E4981A-04

E4981A Capacitance Meter, 120 / 1 kHz / 1 MHz"

A31 Digital Board Replacement Procedure

E4980-66531**E4980-66631**

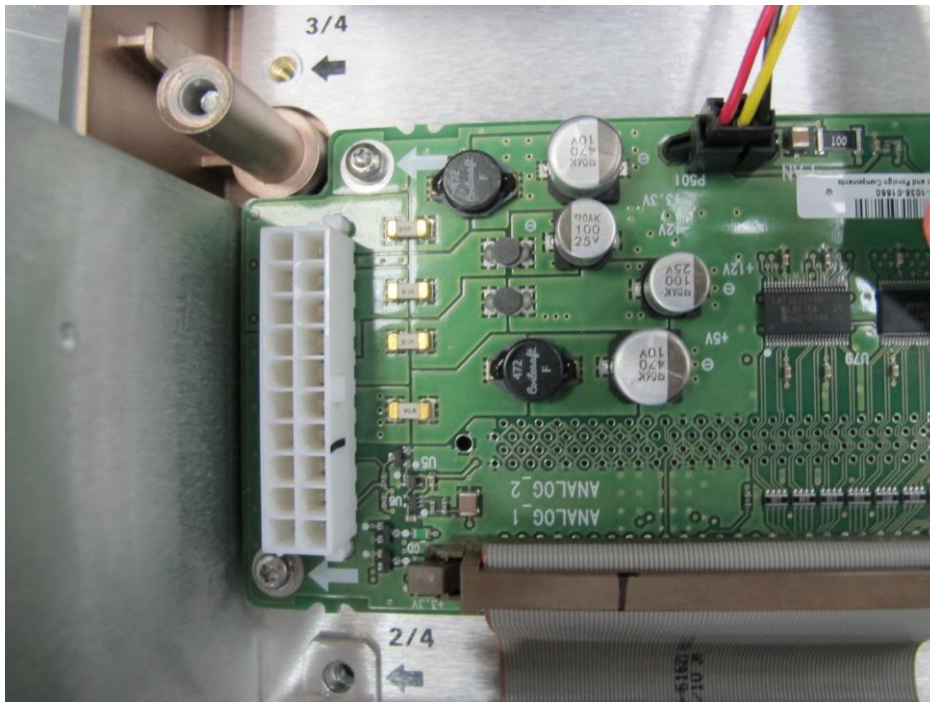
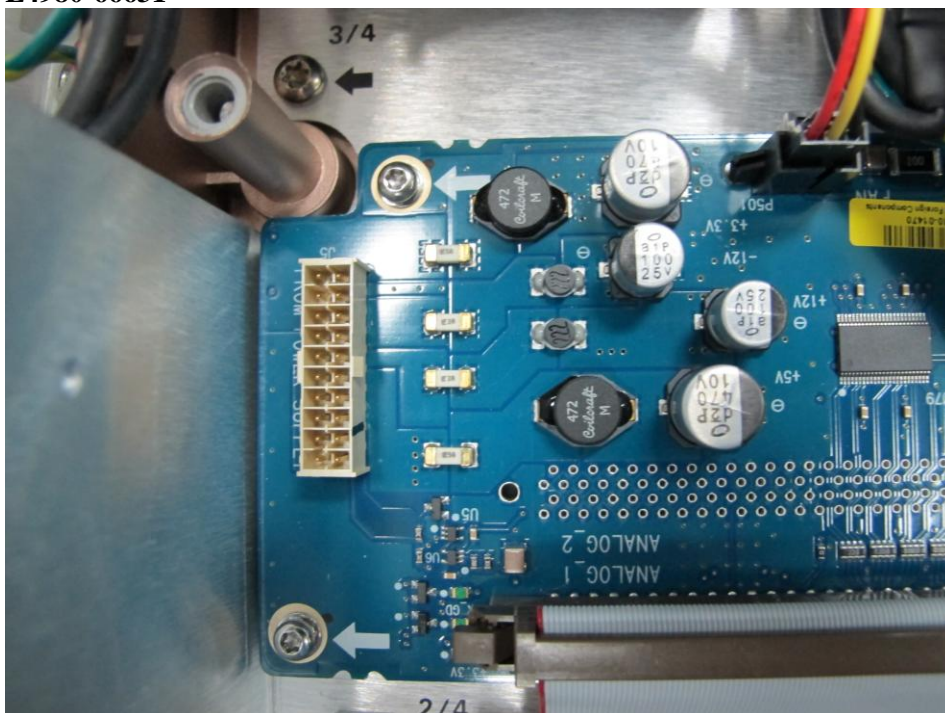
Power supply cable assembly needs to be replaced as **E4980-66631** is having different connector with previous board **E4980-66531**.

When repairing E4981A instrument A31 Digital Board, order **E4980-66631** Pb-free, Digital PCBA & **E4980-61627** Power cable assembly.

Figure 1-1

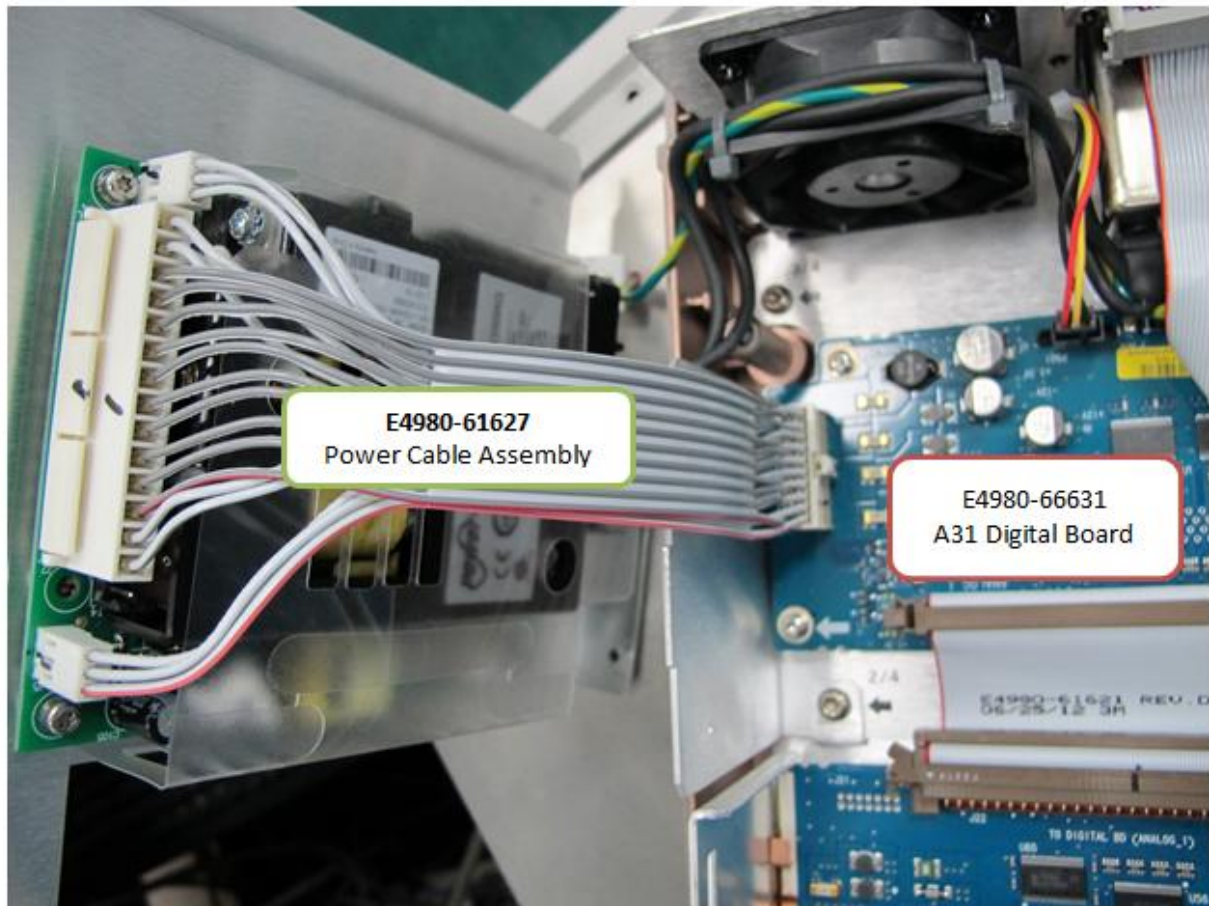
1. Refer to service guide for the removal procedure – Chapter 6- “A31 Digital Board Assembly Replacement”
2. Install the A31 Digital board **E4980-66631** onto the unit as shown in figure 1-1.
3. Connect the power cable assembly **E4980-61627** from power supply unit to A31 Digital board.

Note: New A31 Digital board **E4980-66631** connector is different dimensionally. When replacing the Digital Board, it is required to replace the **E4980-61627** Power cable assembly as well. Power supply unit could be re-used and not required to be replaced.
